PACIFIC GAS AND ELECTRIC COMPANY
Wildfire Mitigation Plans Discovery 2023
Data Response

PG&E Data Request No.:	MGRA_004-Q003		
PG&E File Name:	WMP-Discovery2023_DR_MGRA_004-Q003		
Request Date:	April 28, 2023	Requester DR No.:	MGRA-PGE-WMP23_No.4
Date Sent:	May 9, 2023	Requesting Party:	Mussey Grade Road Alliance
DRU Index #:		Requester:	Joseph Mitchell

SUBJECT: WDRM DATA:

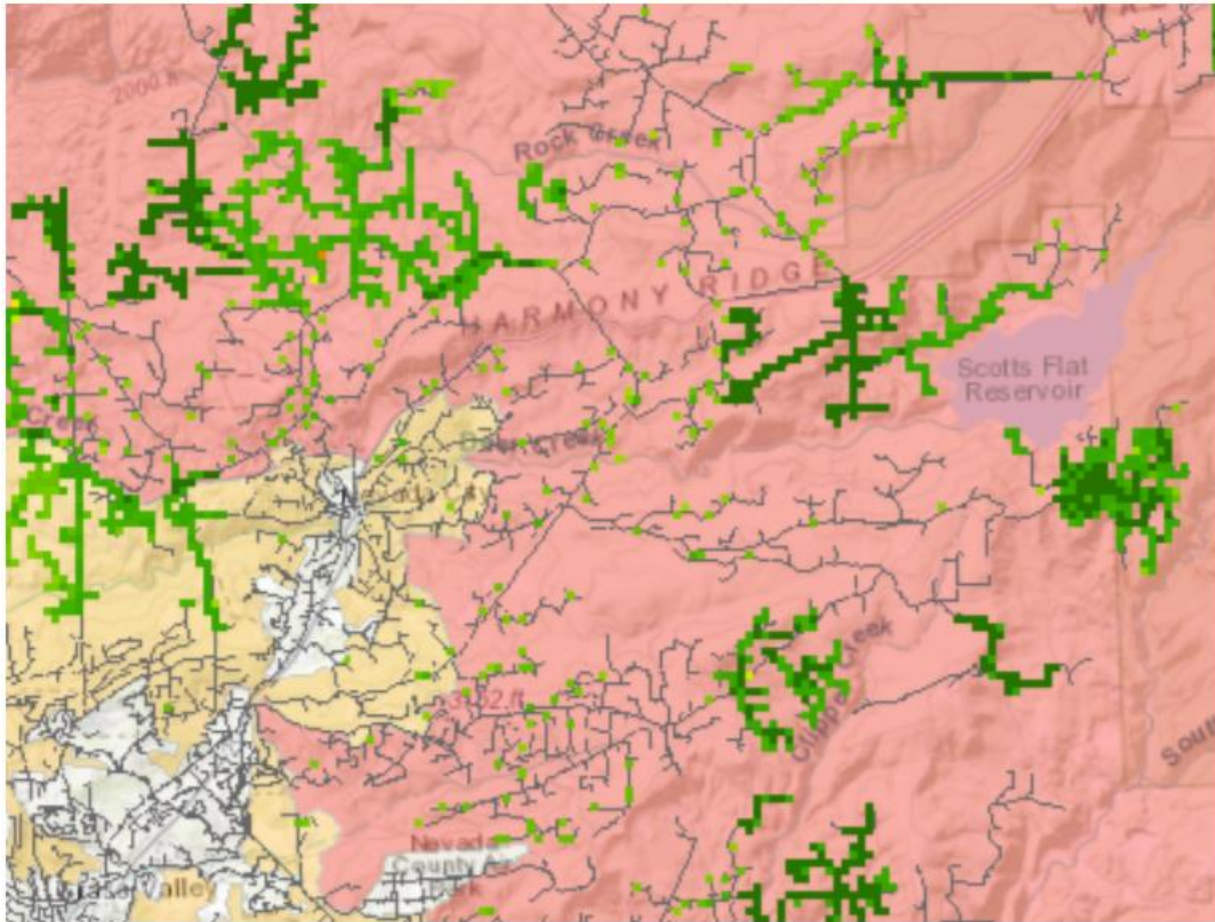
Explain why the polygons do not cover all of the primary distribution lines in the HFTD.
Example below:

Upon review, PG&E has confirmed that the original Attachment 2023-03-27_PGE_2023_WMP_R1_Appendix C_Atch01\Section_6.gdb file inadvertently dropped some risk pixels. Please see "*WMP-Discovery2023_DR_MGRA_004-Q003Atch01.zip*" for an updated GDB file. We will reach out to Energy Safety to provide this updated information pursuant to Energy Safety's guidelines.
